Date September 18, 2019 **Report No.** 2019-579
To Chair and Members
City of Brantford Committee of Adjustment
From Alexandra Mathers
Development Planner

Committee of Adjustment Decision Regarding Applications for Consent and Minor Variance

APPLICATION NO. B28/2019 & A28/2019
AGENT David Johnston
APPLICANT/OWNER 2557860 ONTARIO LTD
LOCATION 18 Easton Road and 131 Lynden Road

Appendix C – Conceptual Site Plan

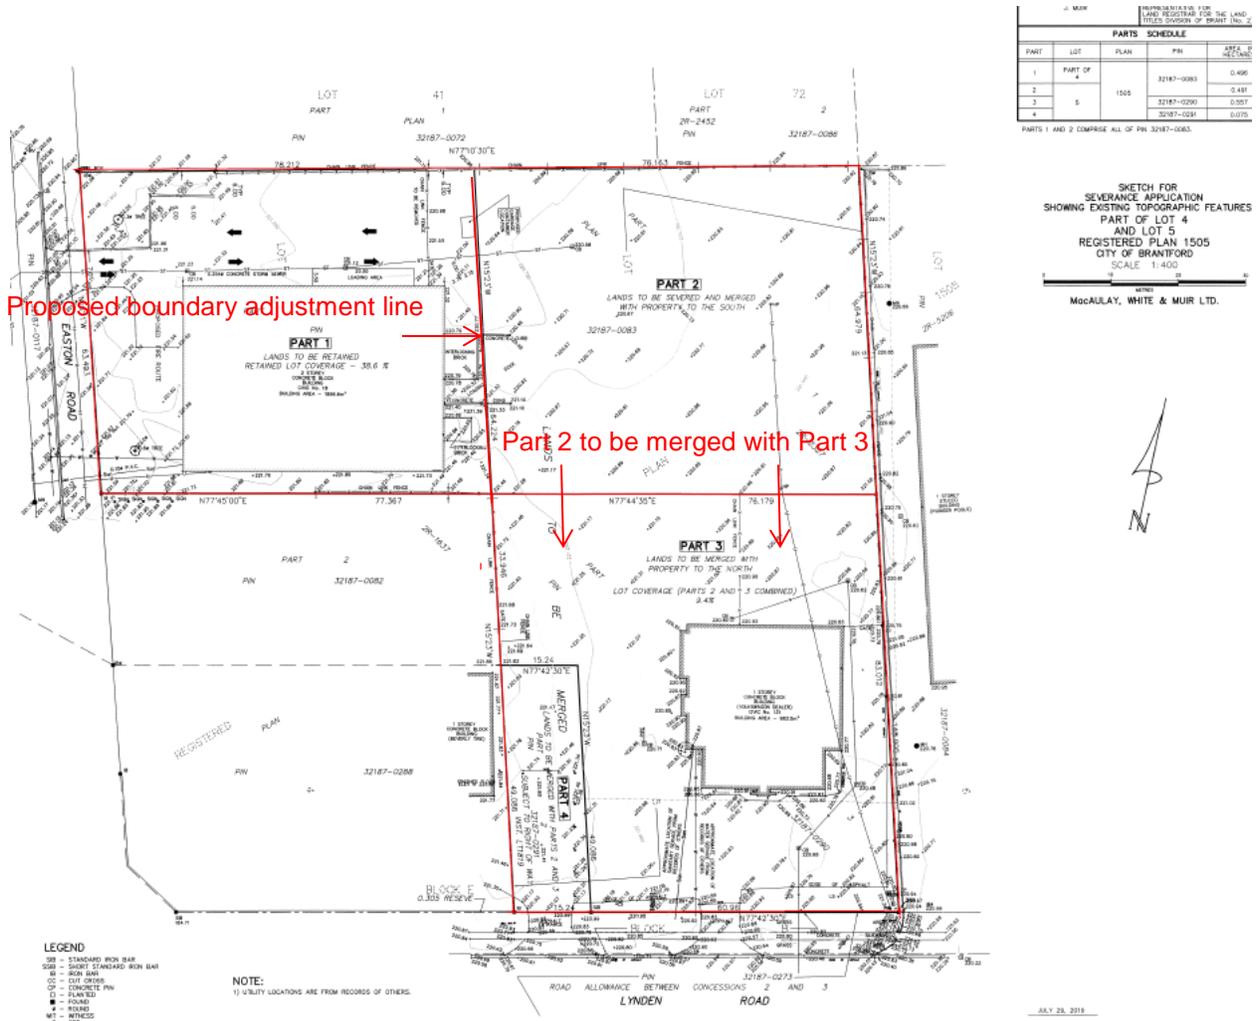
At Planning Staff’s request, the applicant provided some functional concept plans to ensure the retained lands could continue to function. Transportation and Parking Services Staff provided comments on the truck turning plan for the retained parcel at 18 Easton Road, they advised that truck movements would not function as proposed without the vehicle mounting both the driveway curb and front curb. As a condition of the lot adjustment, the applicant will be required to provide and implement a solution for large vehicles to turnaround on the retained lands or through a joint access agreement between the two properties. Transportation and Traffic Services Staff further advises that the changes to the

1. Inconsistencies are noted between the site plan drawing and drawing that includes truck turning analysis. These inconsistencies are related to aspects including, but not necessarily limited to, loading space location and on-site parking.
2. The applicant is encouraged to register on-title an agreement and/or easement for shared access between the two properties permitting access via Easton Road and via Lynden Road for both.
3. The turning movement analysis provided indicates conflicts with the existing site layout (circled in diagram below) that should be addressed prior to severance.

4. The applicant should be aware that the proposed limit to on-site parking is expected to decrease future usability of the property such that some of the typically permitted uses may not be permitted based on the existing building gross floor area (GFA).
